## Technical Service Bulletin

GROUP <b>RECALL</b>	NUMBER <b>16-01-042</b>
DATE <b>OCTOBER 2016</b>	MODEL(S) <b>GENESIS COUPE (BK)</b>

**SUBJECT:** PASSENGER OCCUPANT DETECTING SENSOR (PODS) UNIT  
CONNECTOR REWORK (RECALL 151)

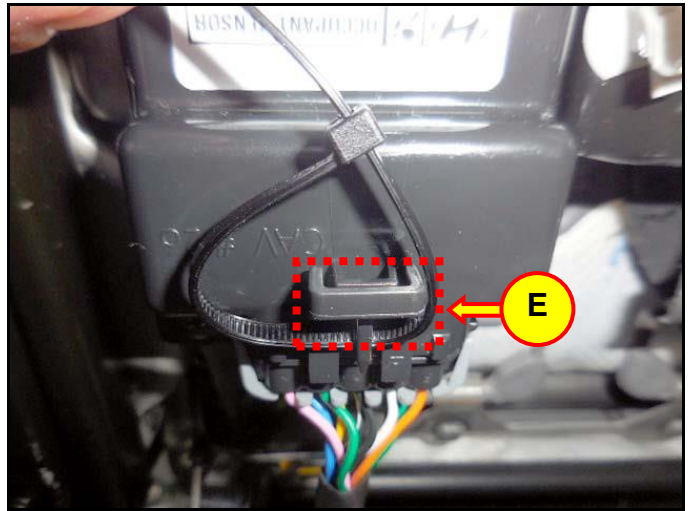
- 7. Insert the cable tie (C) into the PODS unit lock hole (D).

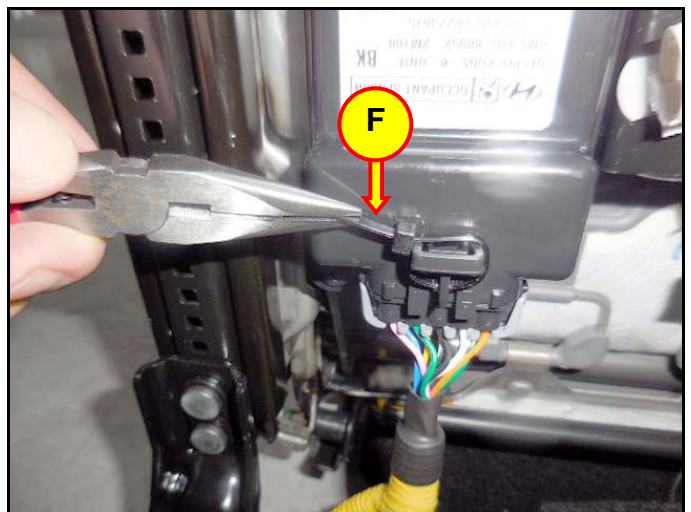
8. Tie the strap around the connector lock side (E).

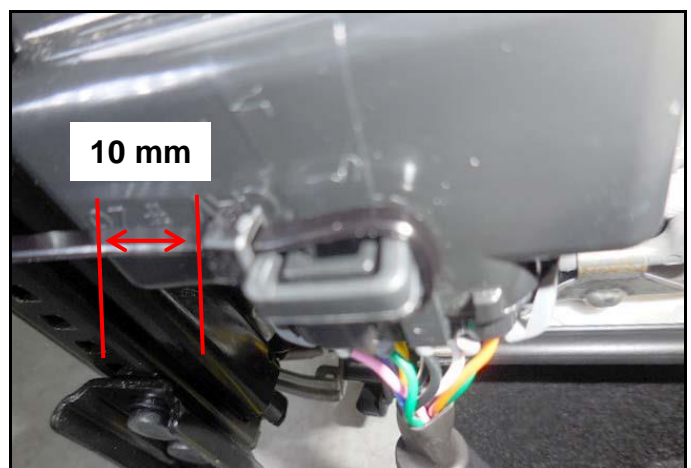
9. Tie the strap (F) tightly.

10. Cut the strap leaving about 10 mm of excess.
